ARCOM # A-24-0072

Siegfried Residence
127 El Bravo Way
Palm Beach, FL

Previously Approved Hardscape Plan

Proposed Hardscape Plan

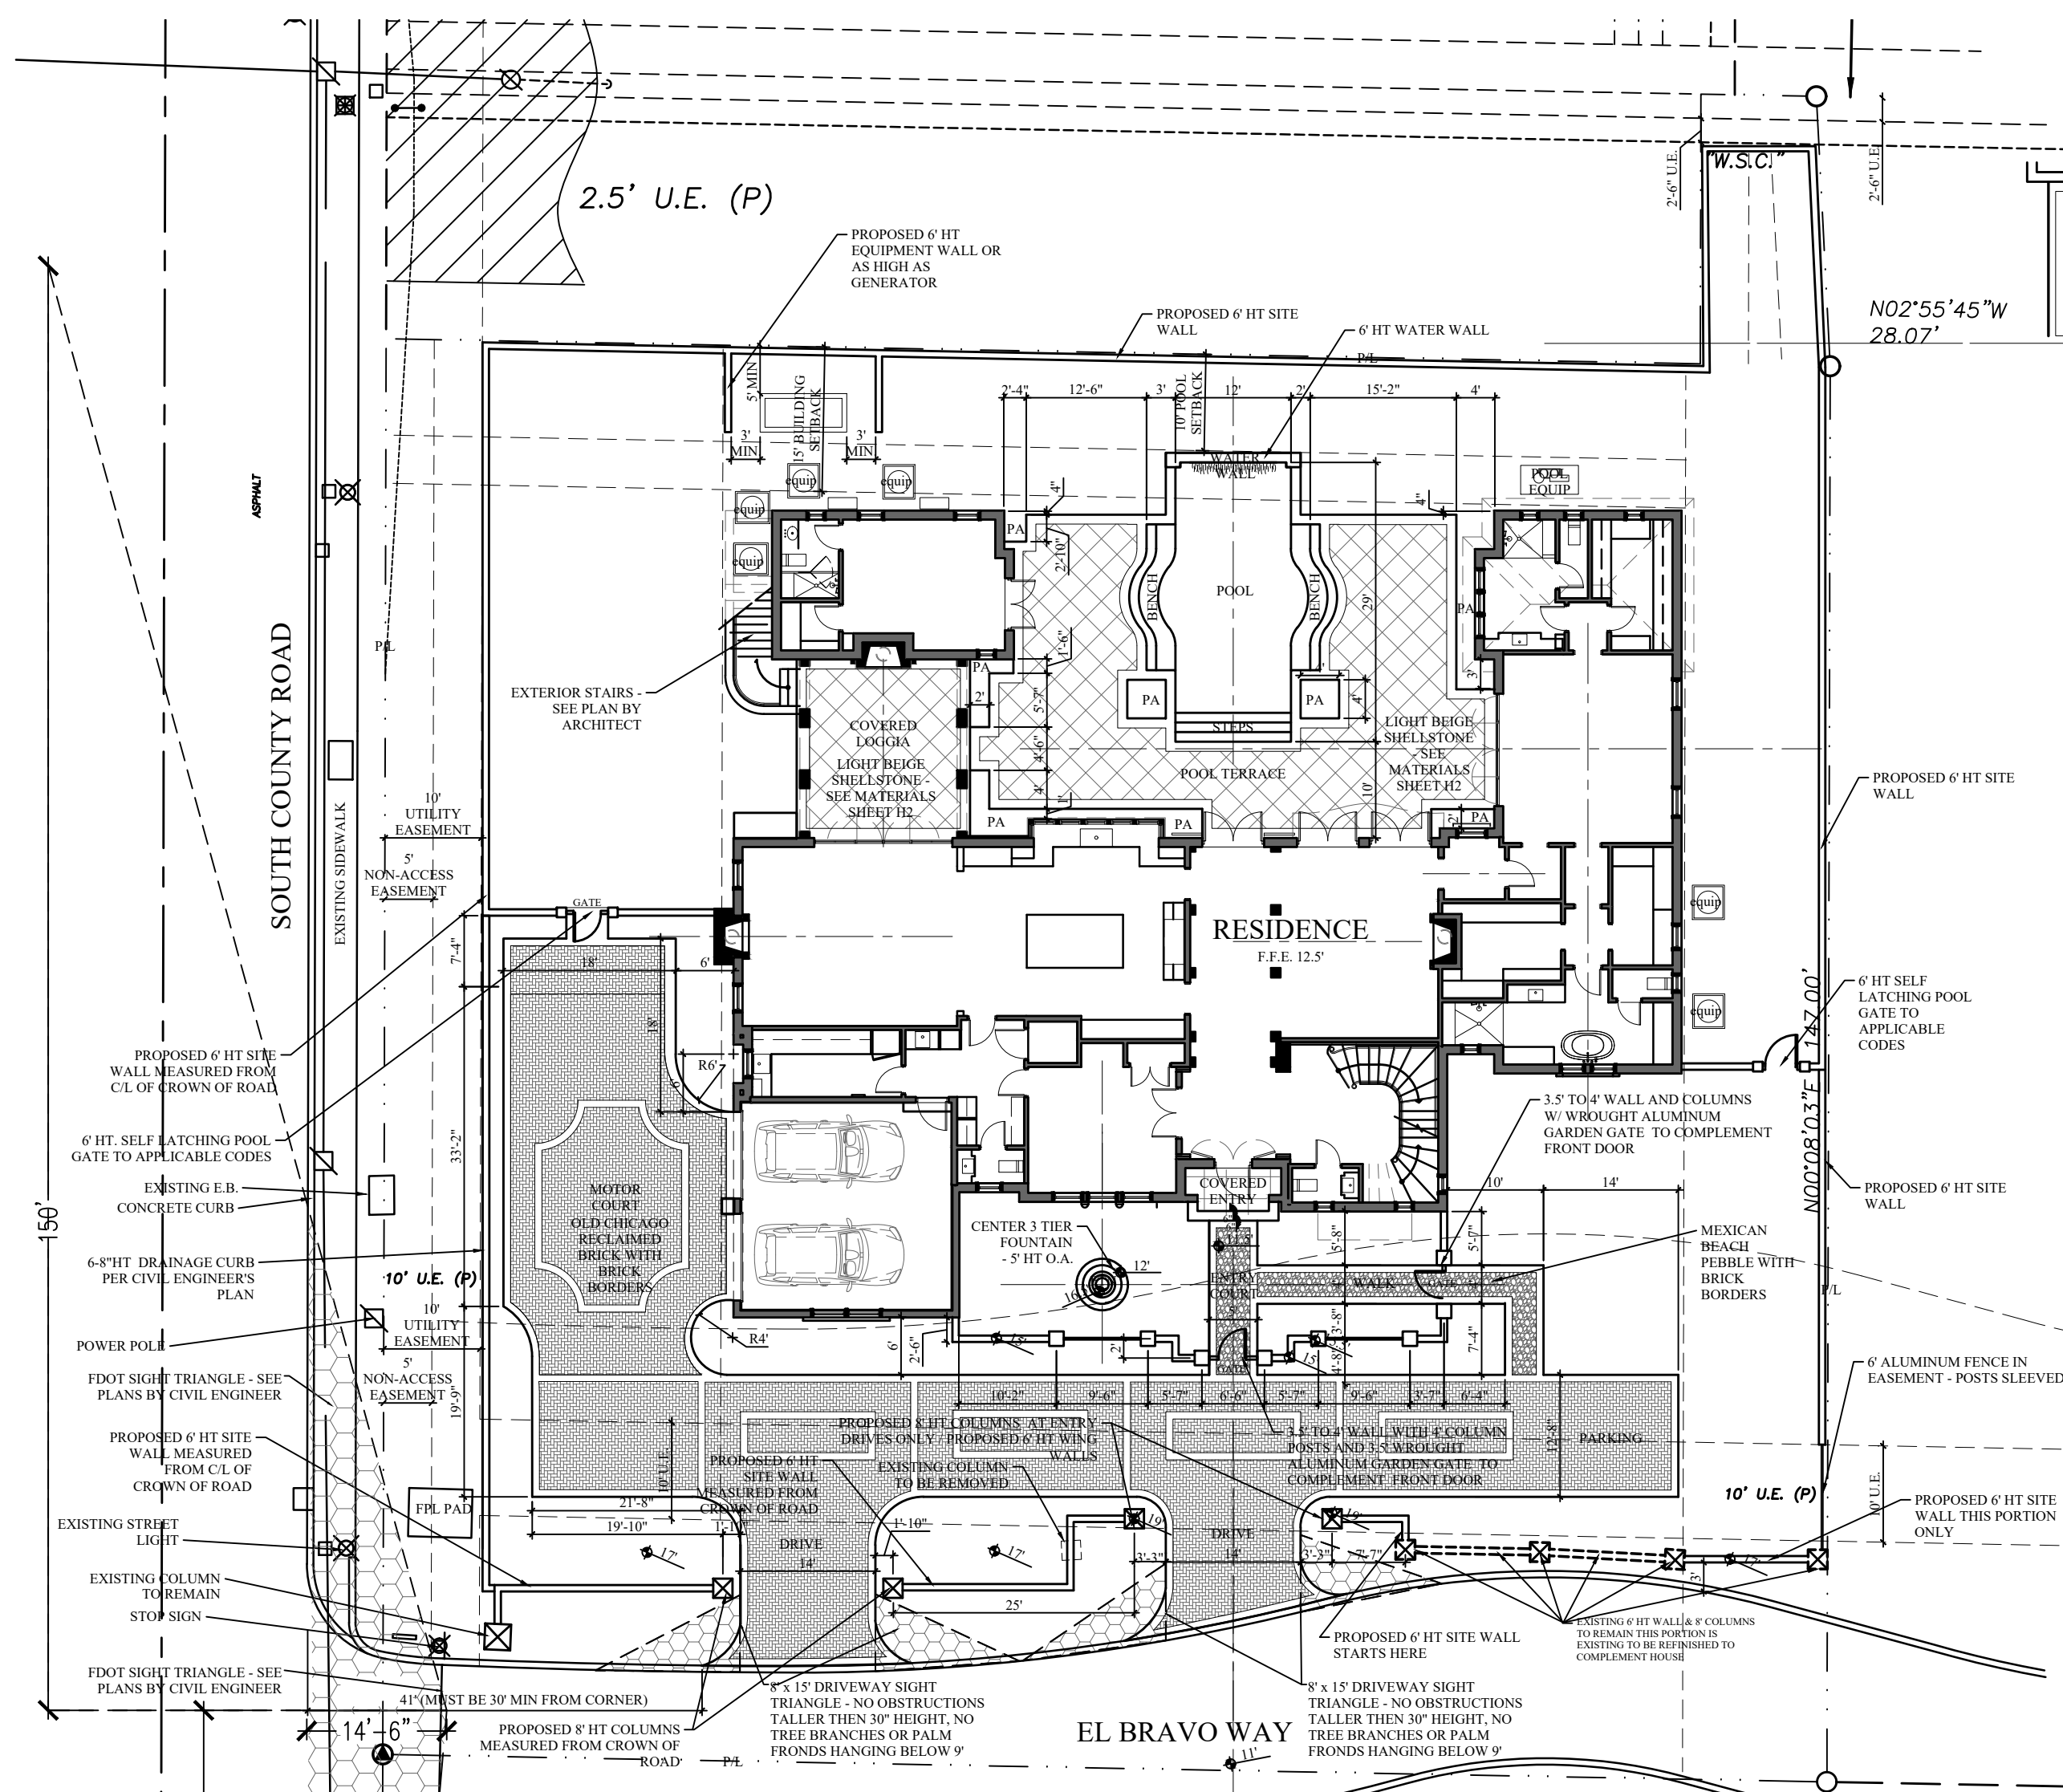
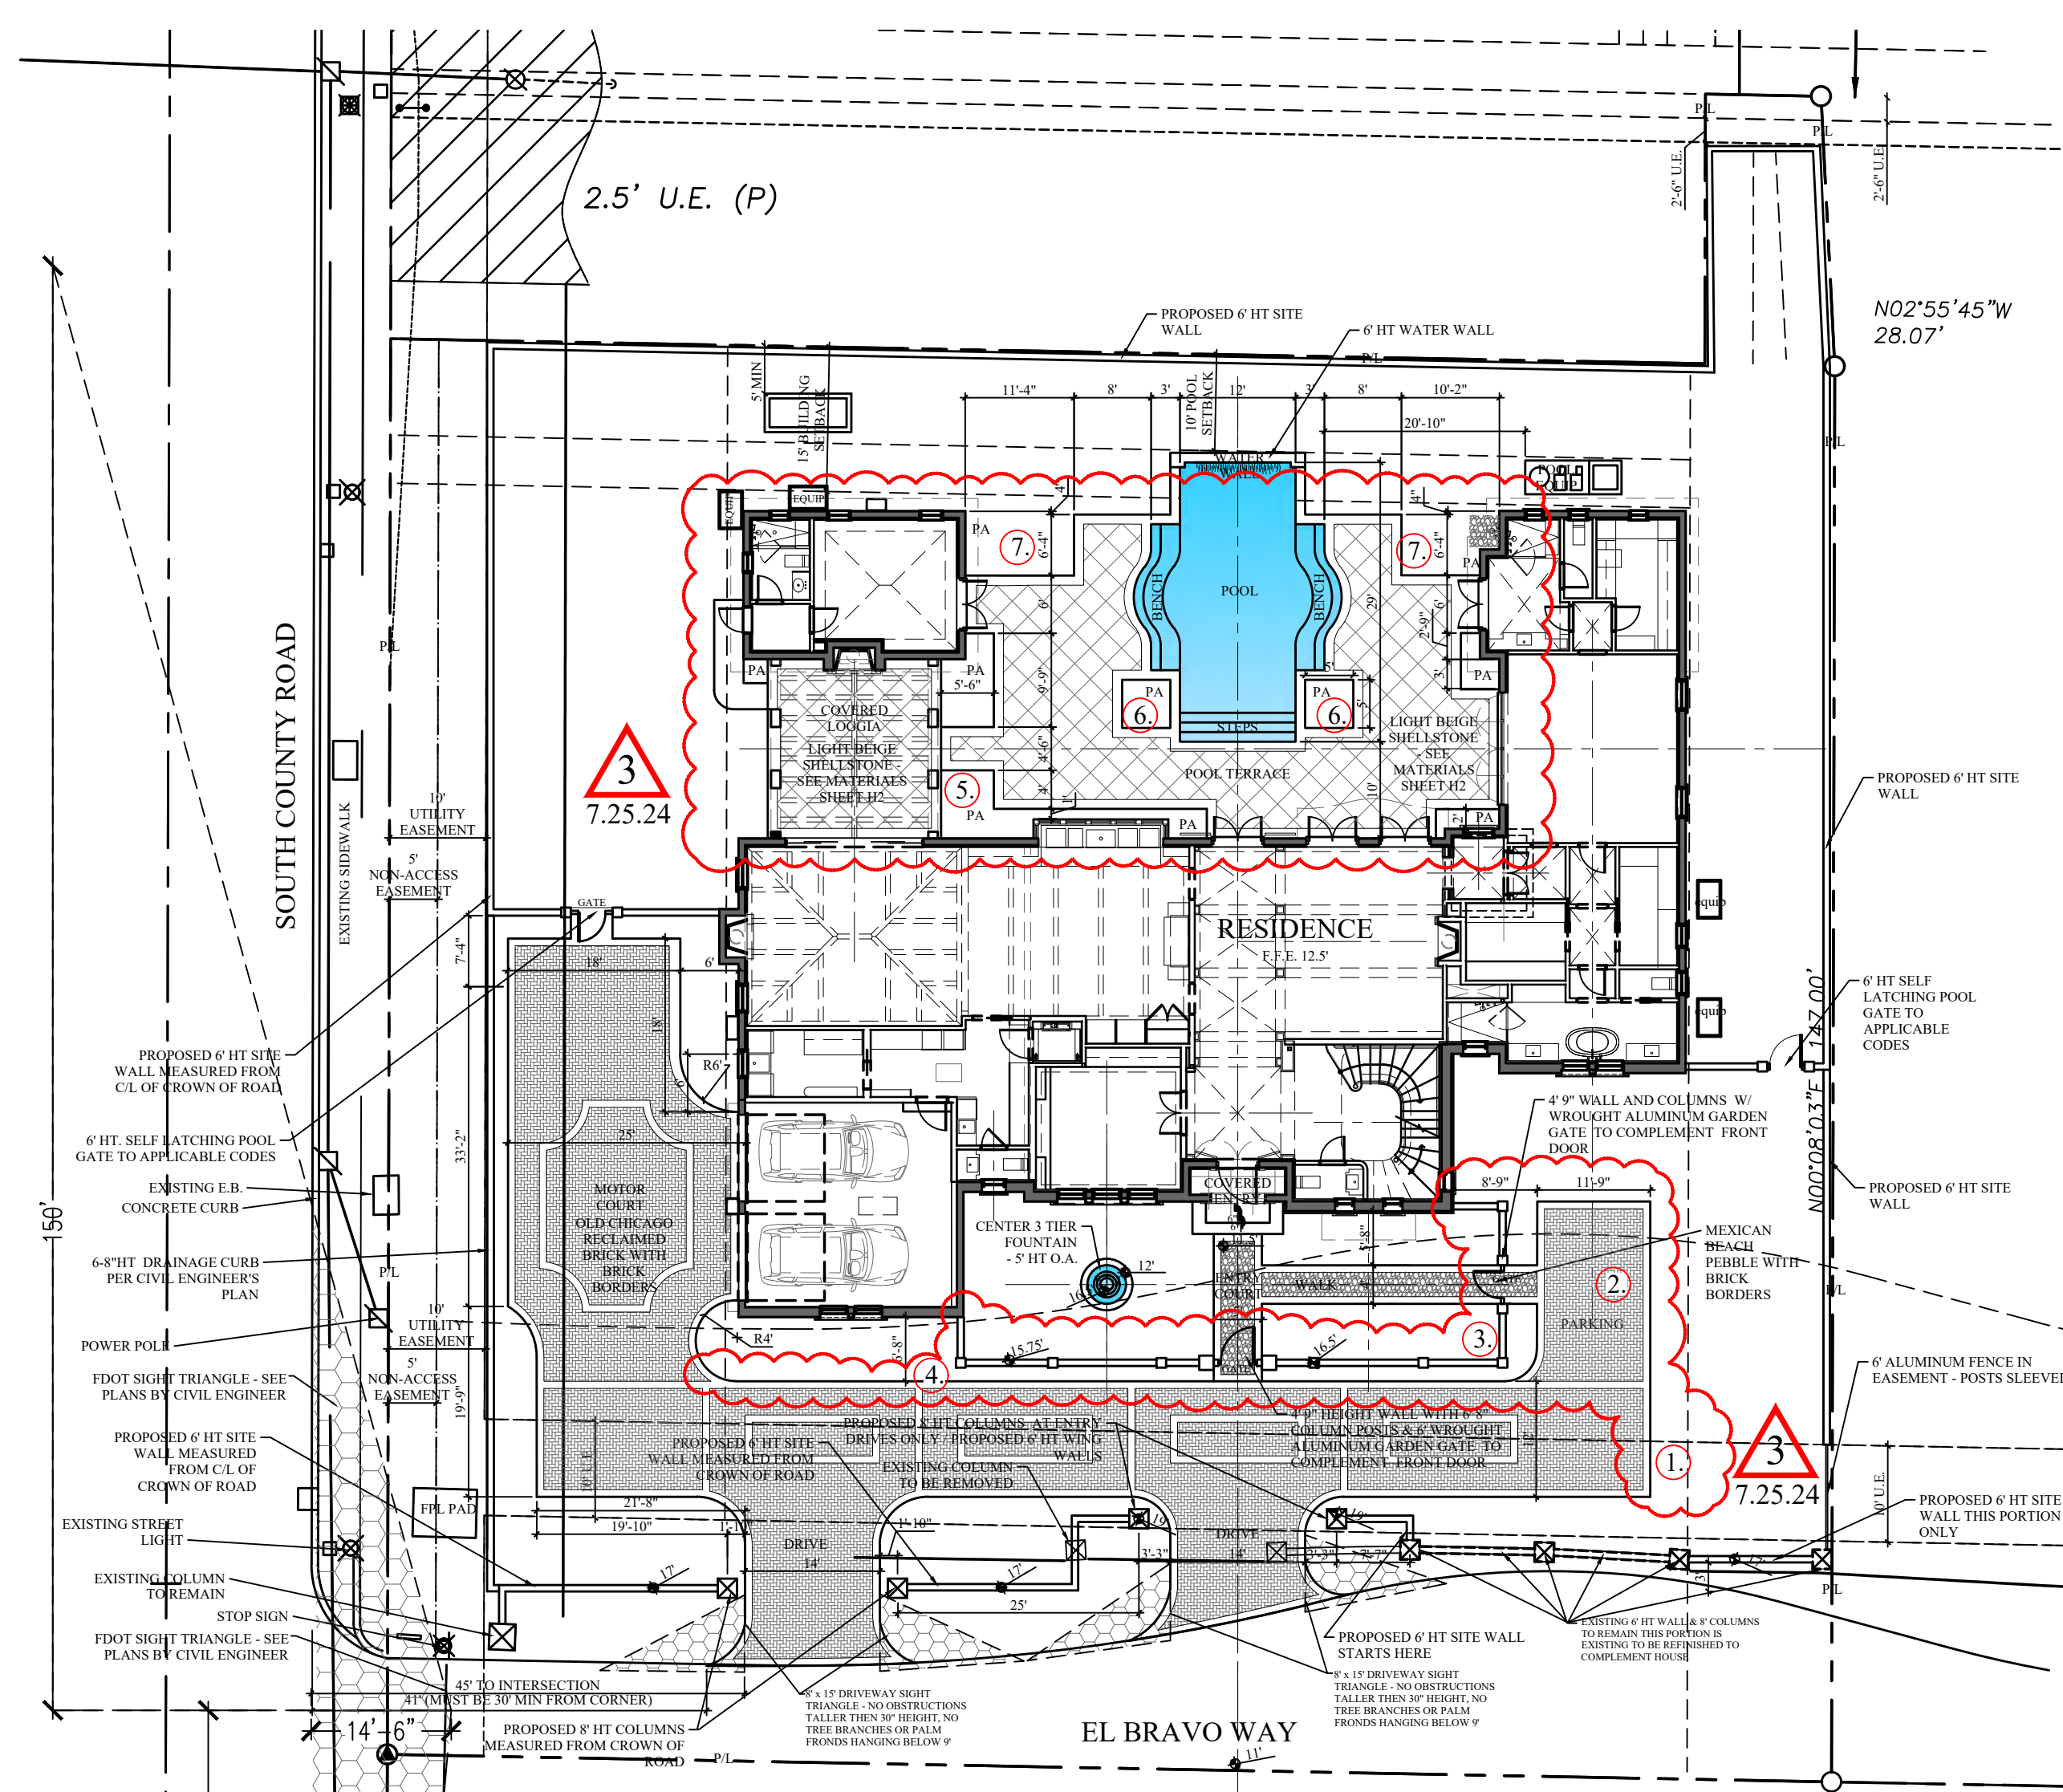
CHANGE LOG
NUMBERS FOR THIS SHEET ONLY

1. REDUCE LENGTH OF DRIVE 3' 5"
2. ADD SMALL PARKING SPACE
3. MOVE GARDEN WALL & GATES
4. NARROW DRIVE 9"
5. EXTEND WALK TO LOGGIA
6. ENLARGE PLANTING PITS
7. REDUCE POOL TERRACE

Proposed Hardscape Plan

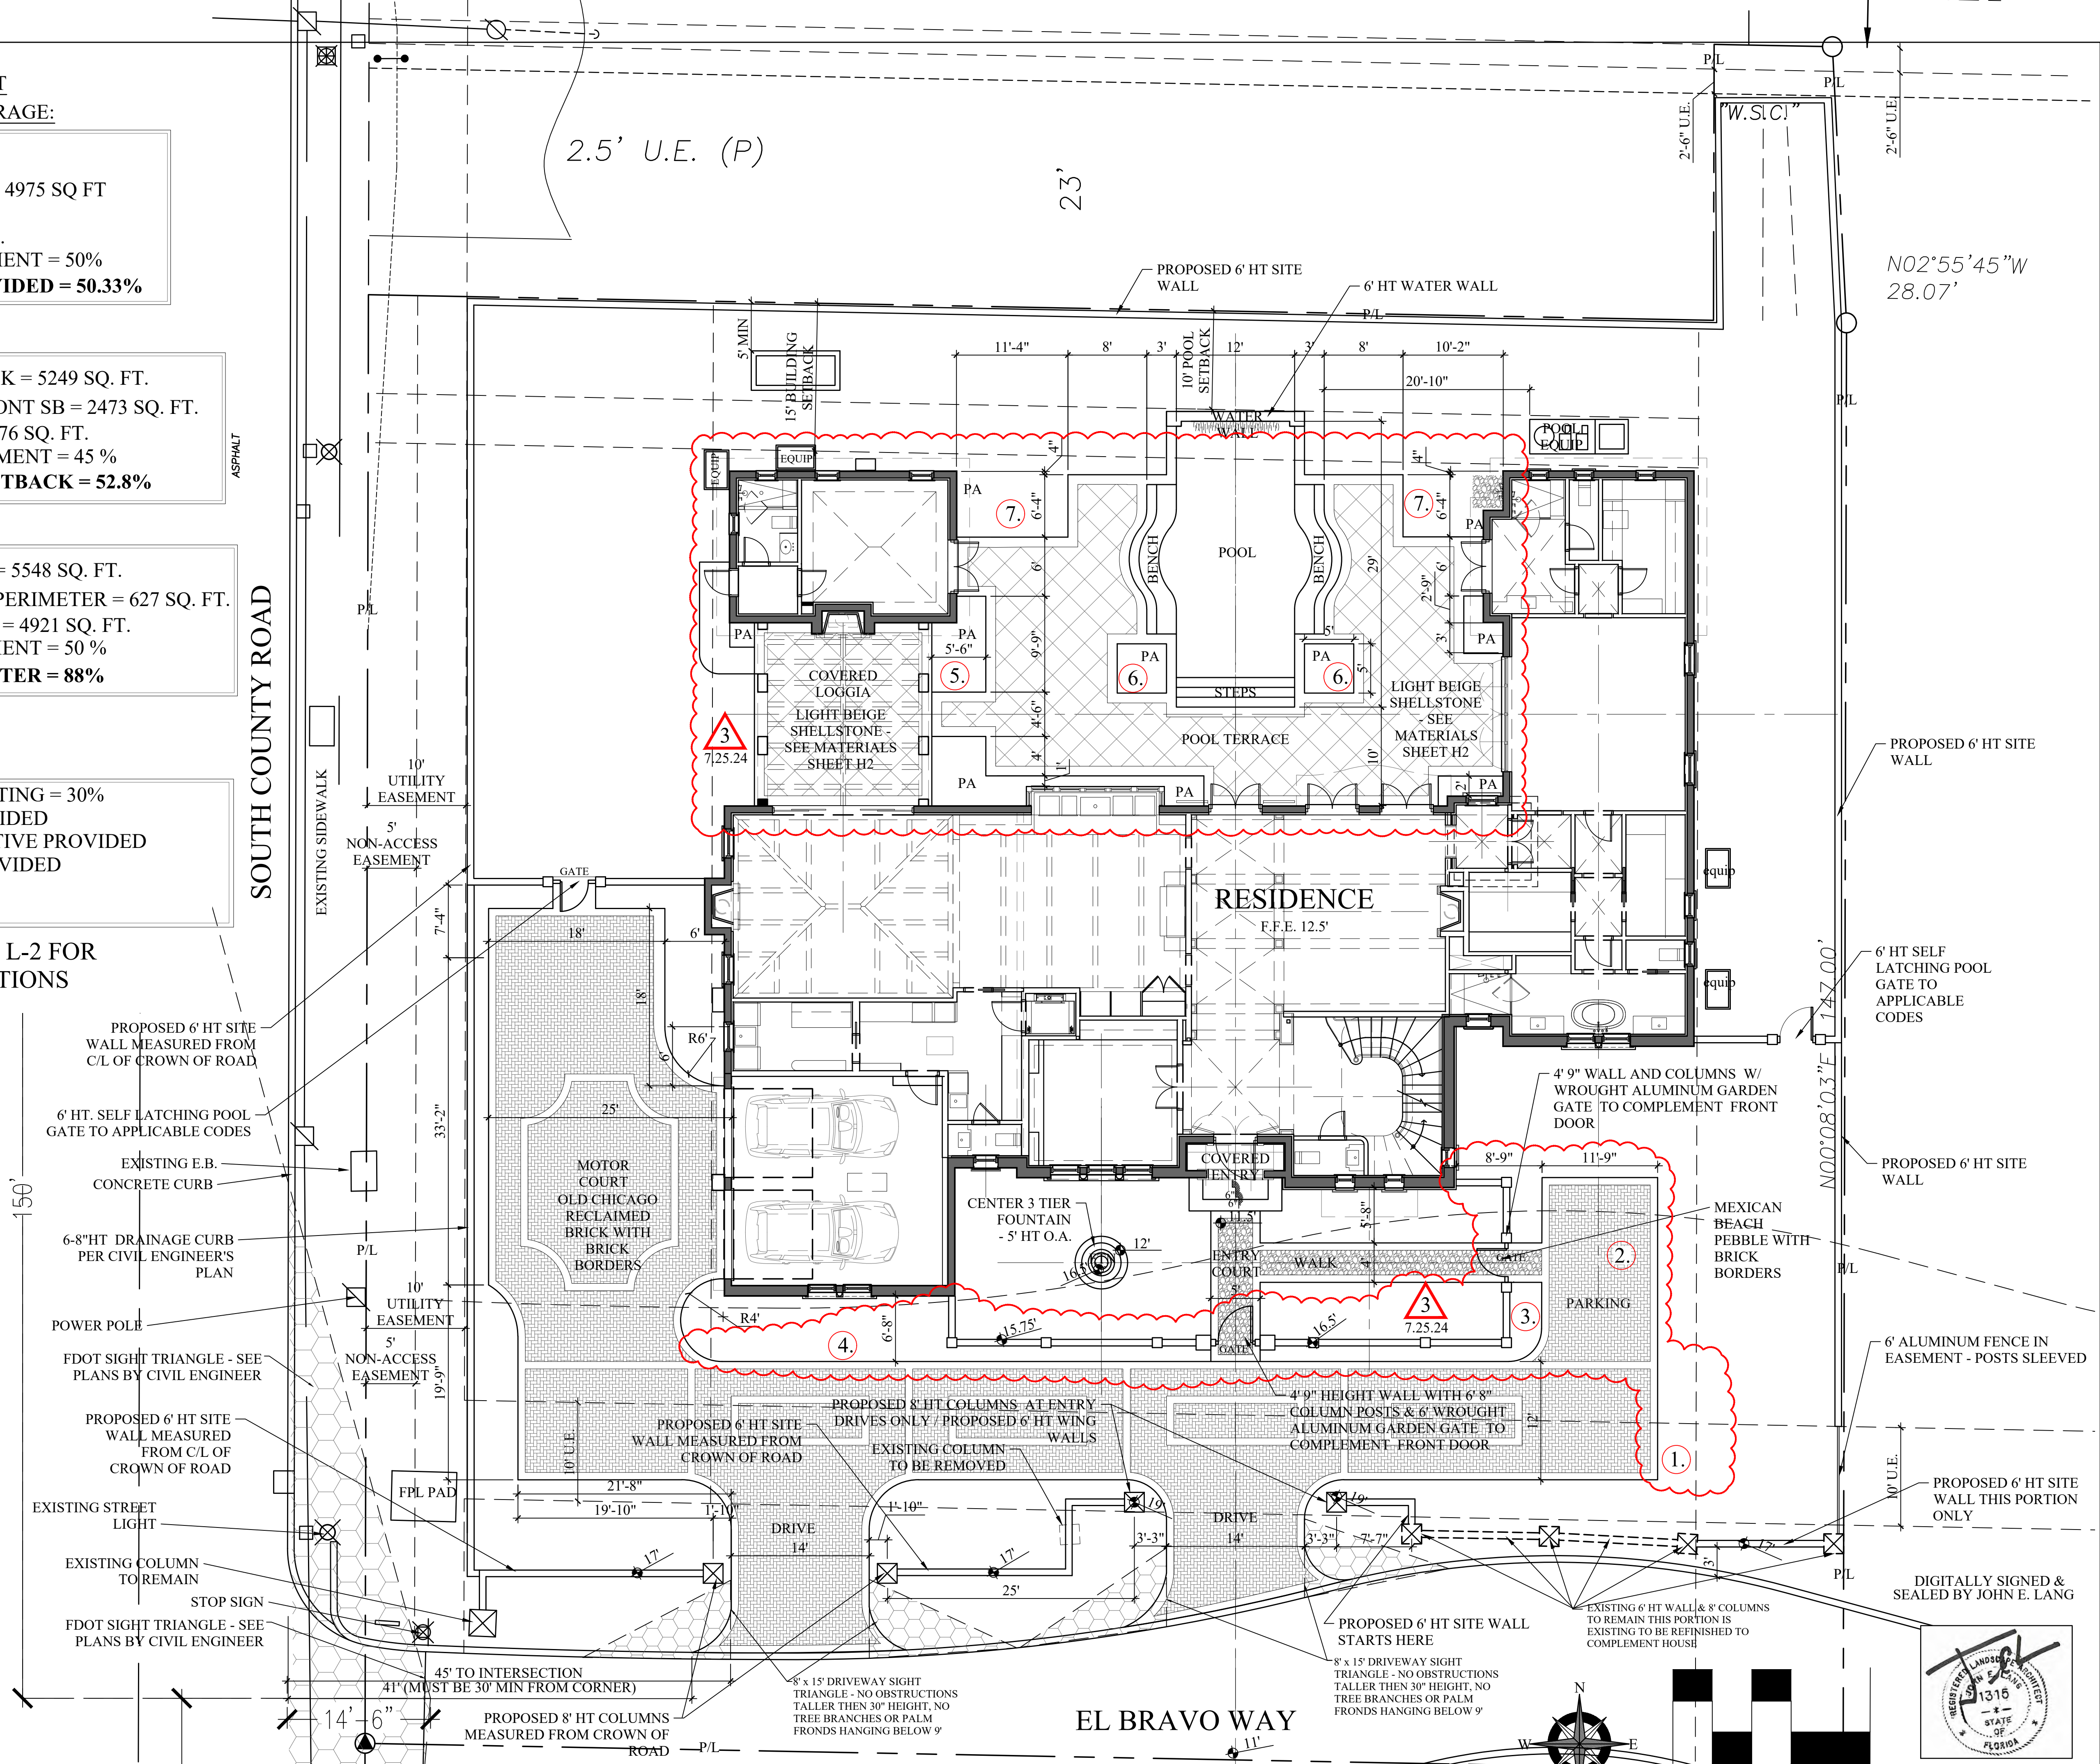
CHANGE LOG

NUMBERS FOR THIS SHEET ONLY

1. REDUCE LENGTH OF DRIVE 3' 5"
2. ADD SMALL PARKING SPACE
3. MOVE GARDEN WALL & GATES
4. NARROW DRIVE 9"
5. EXTEND WALK TO LOGGIA
6. ENLARGE PLANTING PITS
7. REDUCE POOL TERRACE
